# EQUIPMENT UPDATE

**Log Number:** EU-10-368

**Part:** L-1X16 and L-1X Machine Harness Plug

## **L-1X MACHINE HARNESS PLUG**

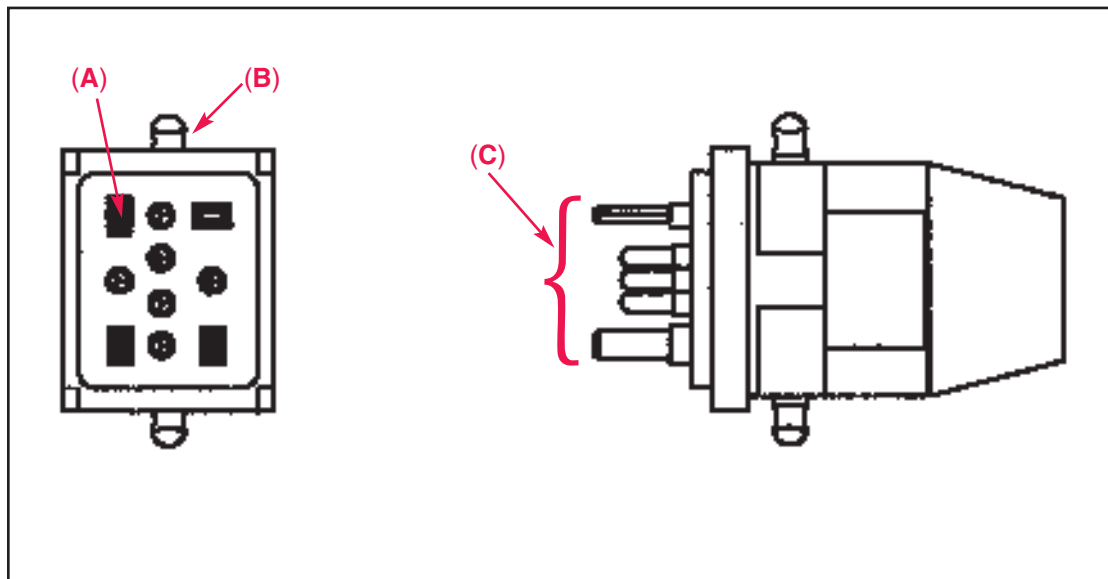
Improvement: New style 10 position plug has been updated with heavy duty, high-current connectors. The locking feature of the molded plug provides secure and water tight connection. The new connecting terminals reduce oxidation which can cause equipment malfunction.

- (A) High-current Connectors
- (B) Locking Features
- (C) Connecting Terminals
